**LIFT STATIONS REHABILITATION - PHASE 5**  
**Solicitation Number: CO-00483**  
**Job No.: 16-2502**

**ADDENDUM 4**  
**November 30, 2021**

**RESPONSES TO QUESTIONS**

**CHANGES TO THE PLANS**

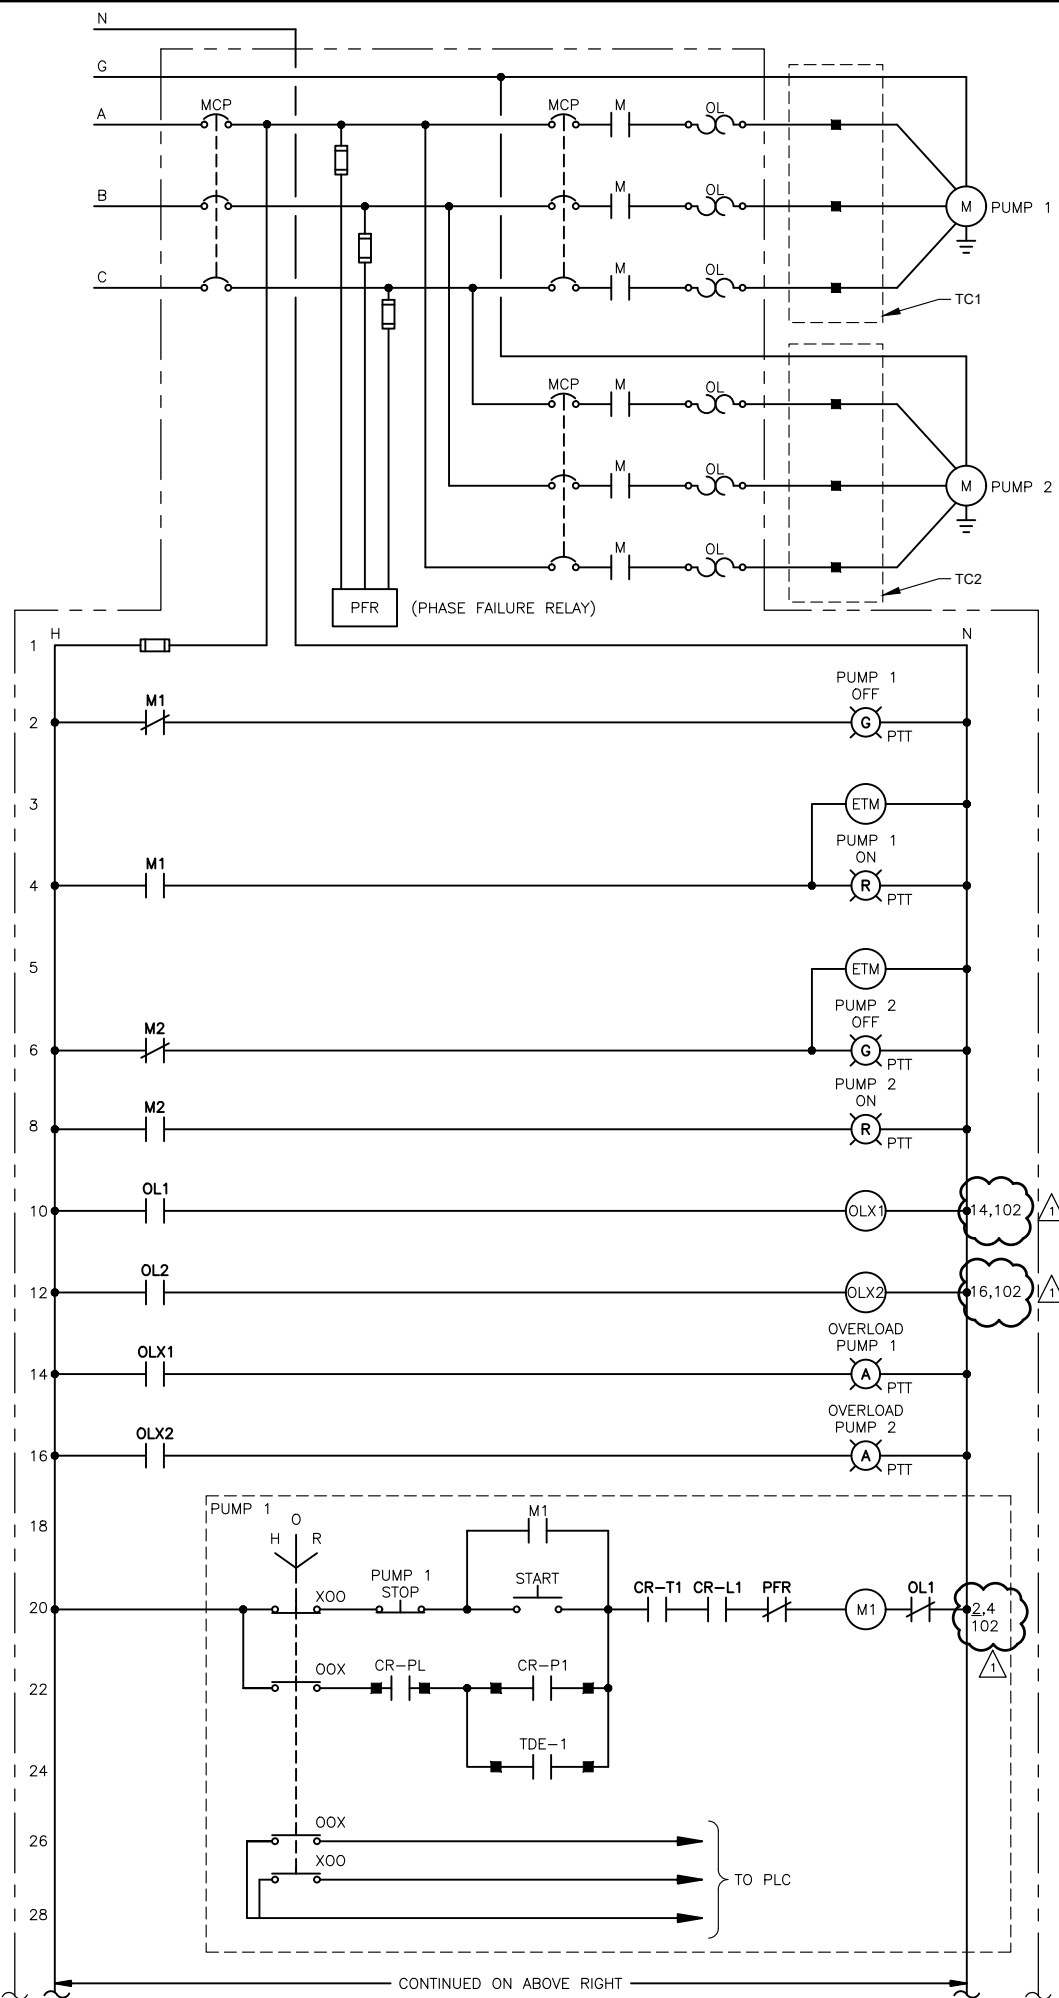
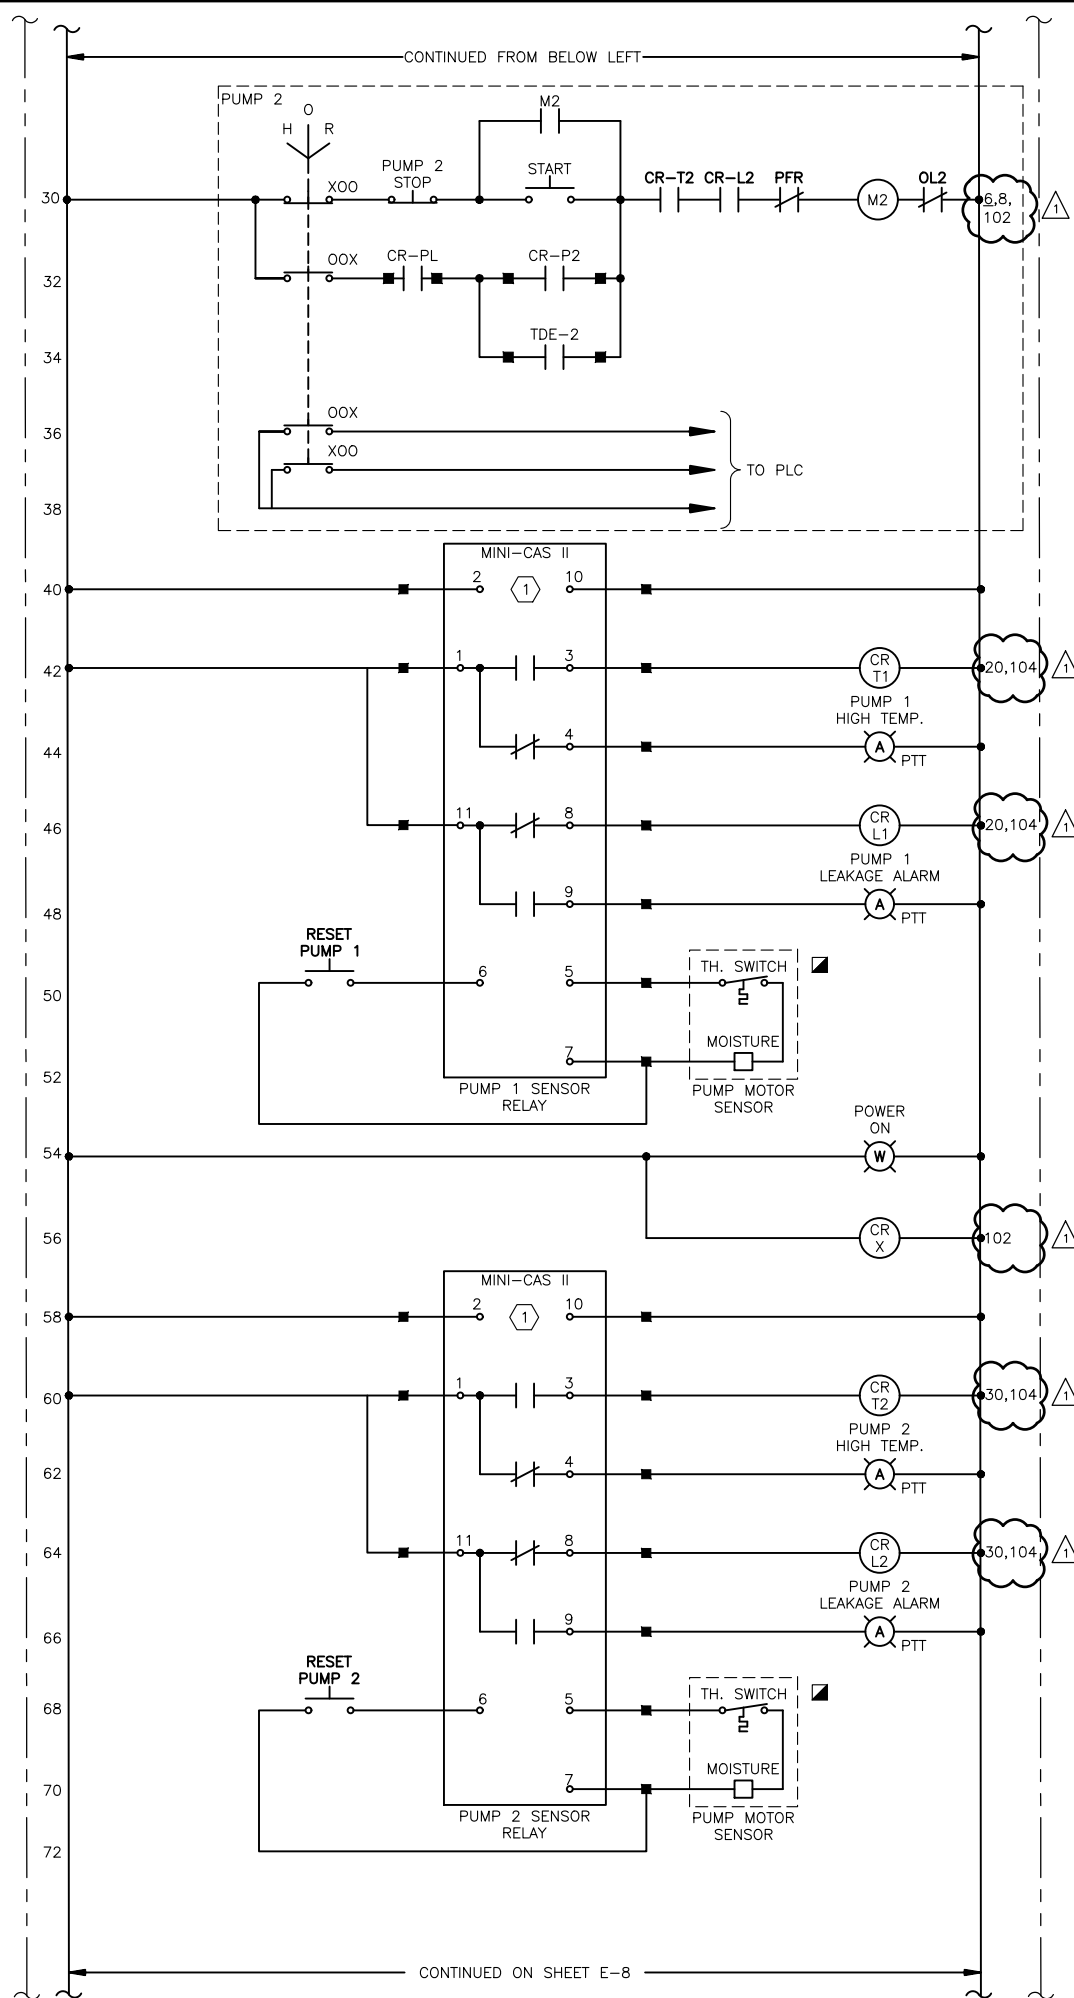
- Question:** Sheet E-7 – The circuit shows a Main MCP motor breaker but on Sheet E-8, there is only Pump Breaker Rotary disconnects, should we provide a Rotary disconnect for the MCP also?

- Sheet E-7 (143 of 150), revise the ladder lines on the left side of the schematic to show the correct references of the contacts. Refer to the revised drawing attached.
- Sheet E-8 (144 of 150), revise the ladder lines on the left side of the schematic to show the correct references of the contacts. Refer to the revised drawing attached.
- Sheet E-8 (144 of 150), revise Pump Control Panel Detail A to show a flange mounted disconnect handle on the panel exterior door. Refer to the revised drawing attached.

**Response:** *For the main panel breaker, a flange mounted disconnect operating handle shall be provided on the panel door as required per Specification 16487 – 2.04.B. The pump rotary disconnects are to remain as shown on the interior panel door. Drawing will be revised by this addendum to show main flange mounted disconnect handle.*

MAP No. \_\_\_\_\_ SHEET E-8

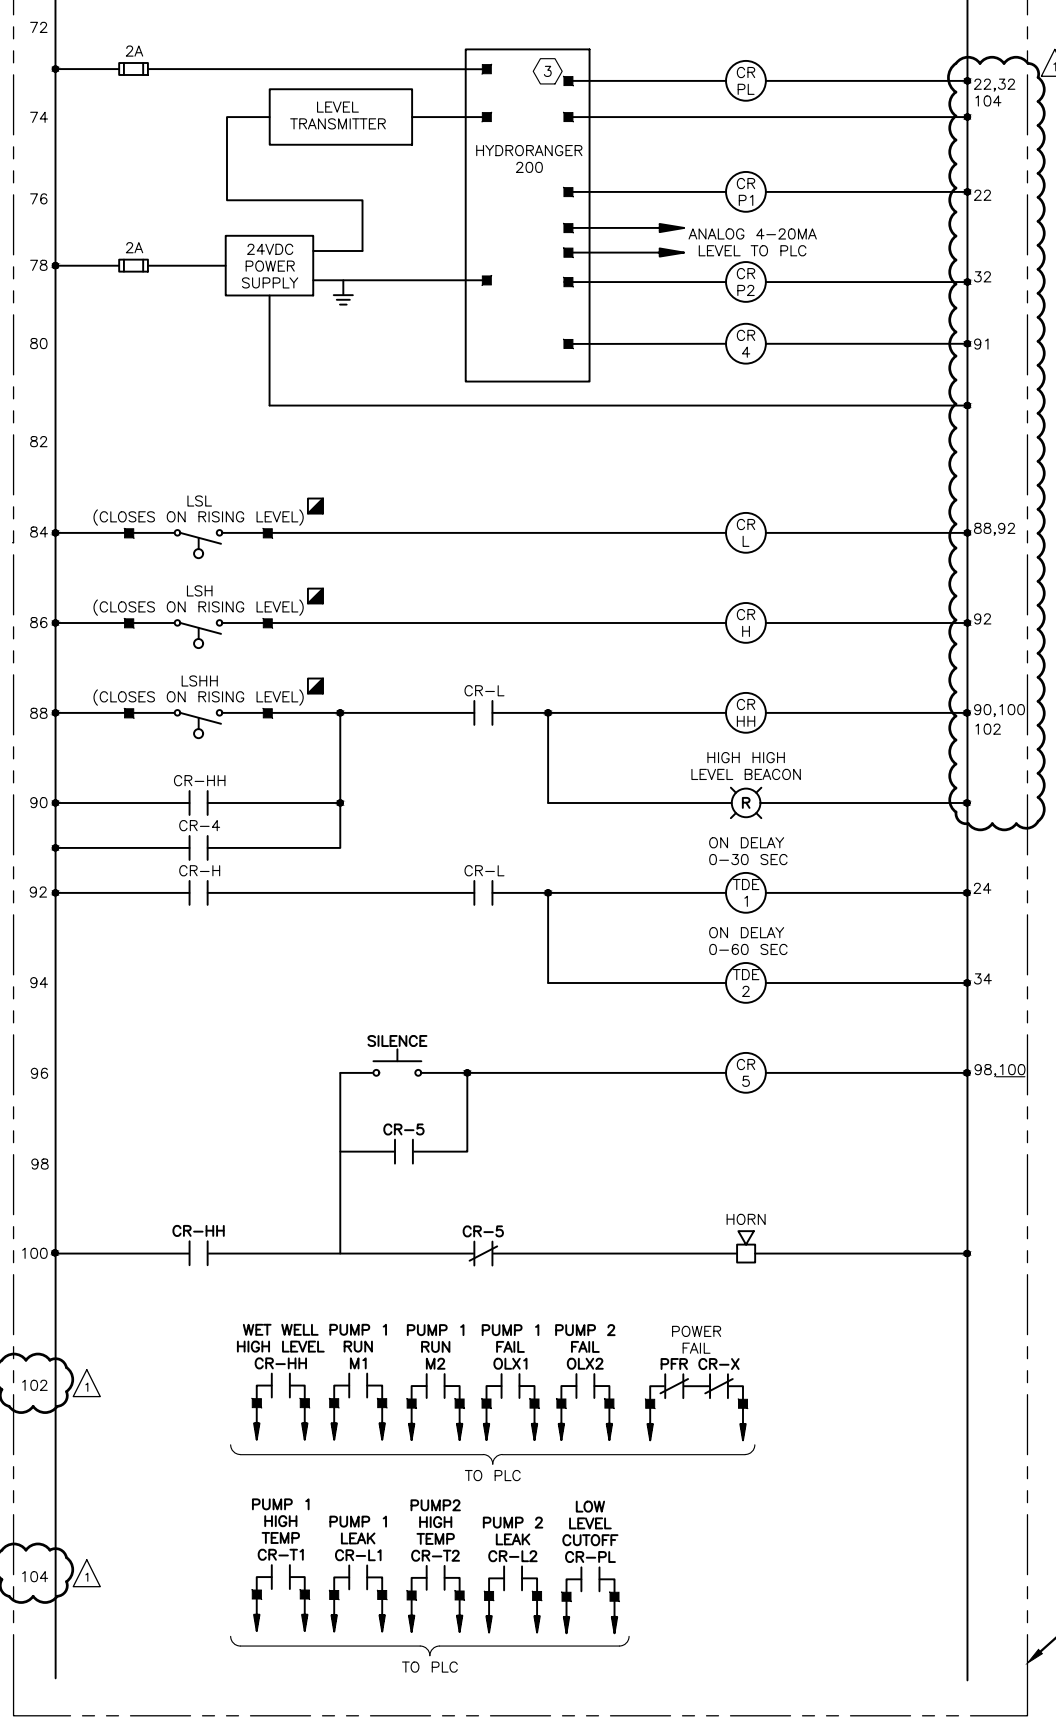
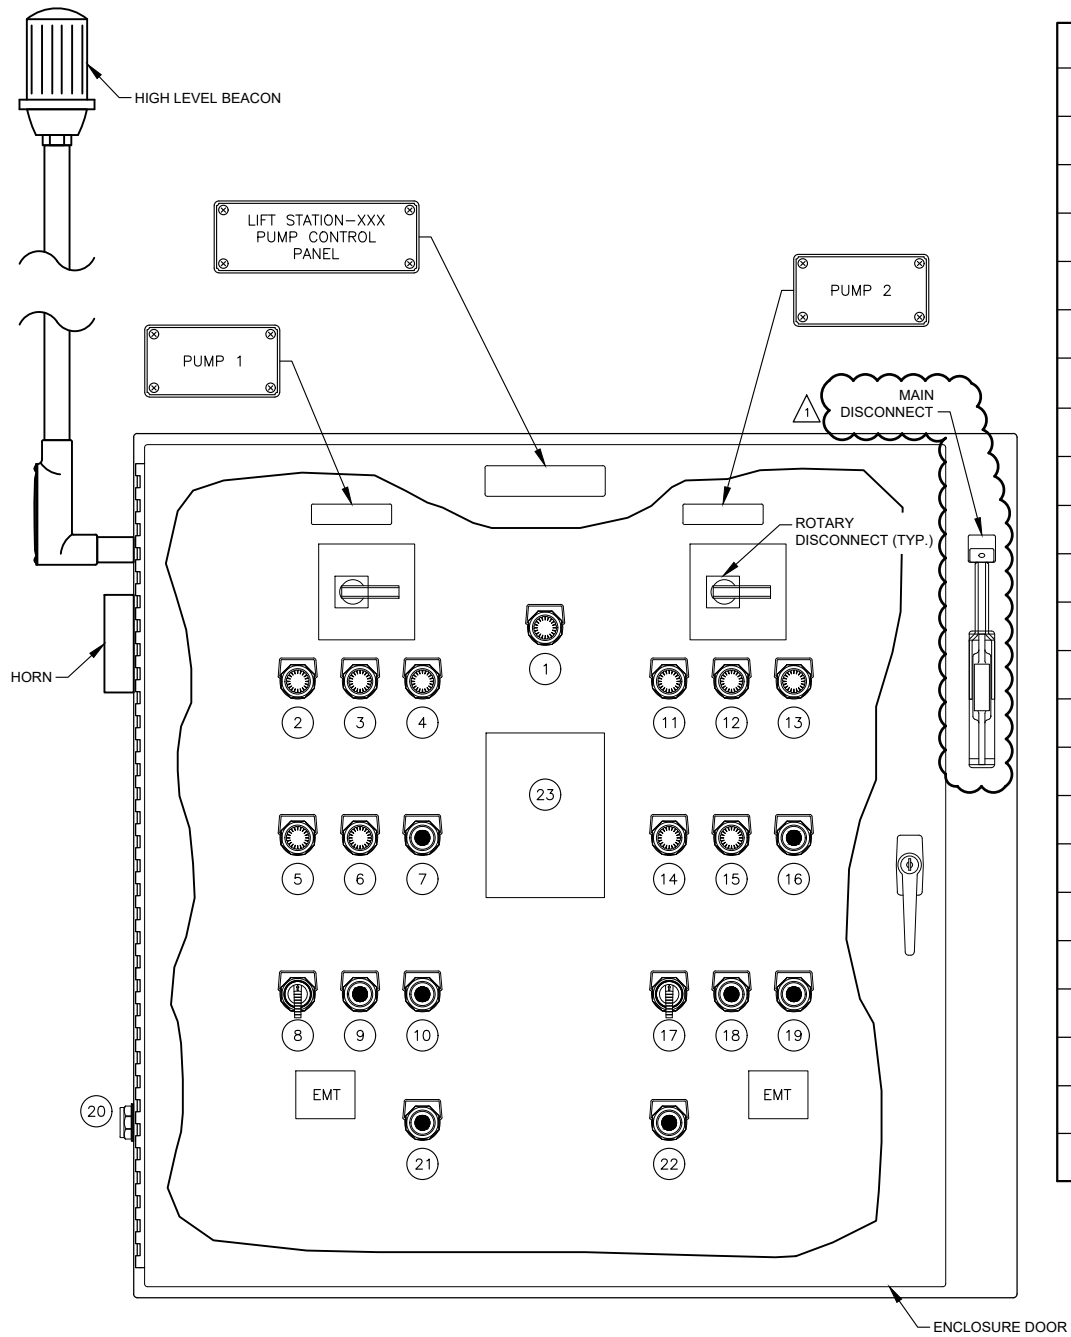
- Question:** Sheet E-8 Schematic 1 – On the ladder diagram 84-86 shows a 3 Float circuit. Typically SAWS only has a High Level Float circuit in their panels. Please verify that this is a new style circuit for SAWS.

**Response:** *Verified. Provide as shown on the Drawings.*
- Question:** Sheet E-8 Schematic 1 – On the Remote Alarm Contacts to the PLC, the Low Level Cutoff is to be provided, typically that has been off the Hydorranger, will this be from the Low Level Float circuit?

**Response:** *Verified. Provide as shown on the Drawings.*
- Question:** Sheet E-13 Detail A shows Floats attached to a weighted cable – This has not been provided for previous SAWS projects, please verify that this is needed.
